**IN THE DRAWINGS**

TITLE: PORT-BASED PACKET FILTER  
INVENTORS NAME: Charles L. Brabec  
SERIAL NO.: 09/746,205

*Fig. 3*

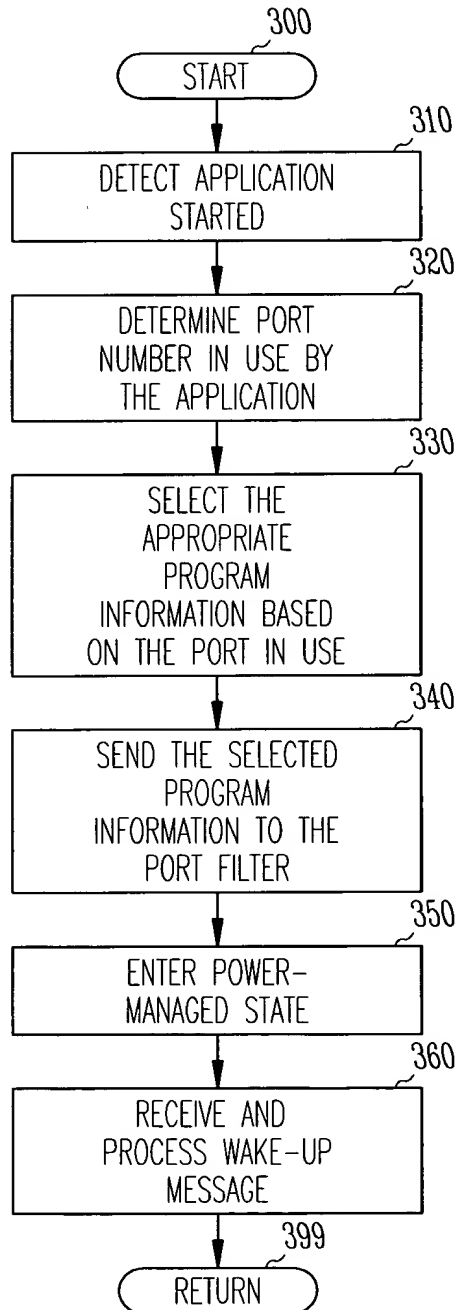
The drawings have been objected to because "port identifier" as per claims 1, 12, and 23 are allegedly not shown in the drawings. Claims 12, 18, 22-24, and 28 have been amended to recite a "port number." Applicant does not concede that 'port identifier' is not shown in the drawings; however, to facilitate prosecution, the above-mentioned claims have been amended. Further, block 320 in Fig. 3 has been amended to "DETERMINE PORT NUMBER IN USE BY THE APPLICATION."
